U.S. NUCLEAR REGULATORY COMMISSION

Docket No: License No:	50-305 DPR-43
Report No:	50-305/99010(DRP)
Licensee:	Wisconsin Public Service Corporation
Facility:	Kewaunee Nuclear Power Plant
Location:	N 490 Highway 42 Kewaunee, WI 54216
Dates:	September 11 through October 19, 1999
Inspectors:	J. Lara, Senior Resident Inspector Z. Dunham, Resident Inspector
Approved By:	Melvyn N. Leach, Chief Reactor Projects Branch 2 Division of Reactor Projects

Kewaunee Nuclear Power Plant NRC Inspection Report 50-305/99010(DRP)

Simplified Drawing

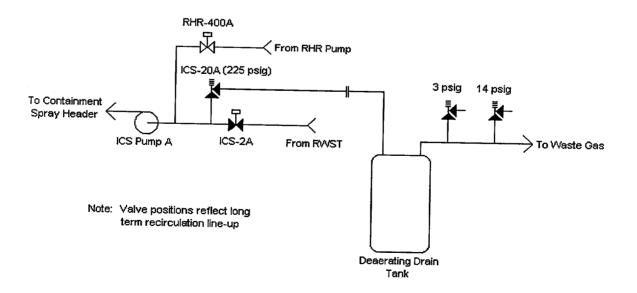
During the observations of the SP, the inspectors noted that the boric acid residue on a coupling downstream of the relief path for relief Valve ICS-20A could be indicative of premature valve lifting or weepage past the valve. This was discussed with licensee personnel for evaluation. Operation personnel had also previously identified the boric acid residue as a recurring condition and were tracking this condition in the Boric Acid Leak Tracking Log. The relief valve was located on the suction piping of ICS Pump A, as shown on the simplified system drawing below:

Additionally, the inspectors questioned licensee personnel regarding the relief valve setpoint. During normal plant operations, the system pressure at the relief valve is the nominal Refueling Water Storage Tank pressure of 25-30 pounds per square inch gage (psig). During the performance of Procedure SP 34-099, the pressure at the relief valve is approximately 180 psig due to the residual heat removal pump providing the supply to the ICS pump, as in the long-term recirculation mode of operation. The relief valve discharge was routed to the deaerating drain tank, which could be potentially pressurized up to 14 psig. The inspectors questioned the licensee as to whether the drain tank back-pressure had been accounted for in the setpoint determination for the relief valves in each ICS train (Valves ICS-20A/B). This was of concern since the relief valve setpoint was set at 225 psig and the ICS pump suction piping design pressure was also 225 psig, as discussed in USAR Section 6.4.2.

The licensee initiated KAP 3480 to document the inspectors concerns. The licensee's prompt operability determination in KAP 3480 was that Valve ICS-20A was operable based on satisfactory leak tests which had been previously performed. Additionally, premature lifting of the relief valve was unlikely based on insignificant changes in drain tank levels logged prior to and following the performance of Procedure SP 34-099. However, the licensee acknowledged that weepage past the valve could occur and that continued evaluation was necessary. The inspectors did not identify any deficiencies with the licensee's operability determination. With respect to the relief valve setpoint, the licensee determined that the drain tank back-pressure had not been accounted for in the determination of the relief setpoint of Valve ICS-20A, but that pipe stress limits would not be exceeded if the relief valve lifted at a higher pressure than 225 psig.

The above issue will be documented as an Unresolved Item (URI) pending further NRC review of the licensee's evaluations of whether the failure to include the back-pressure in the setpoint determination of Valves ICS-20A/B constituted a violation of the licensee's In-Service Test plan (URI 50-305/99010-02, Effect of Back-pressure in the Determination of ICS Relief Valve Setpoint).
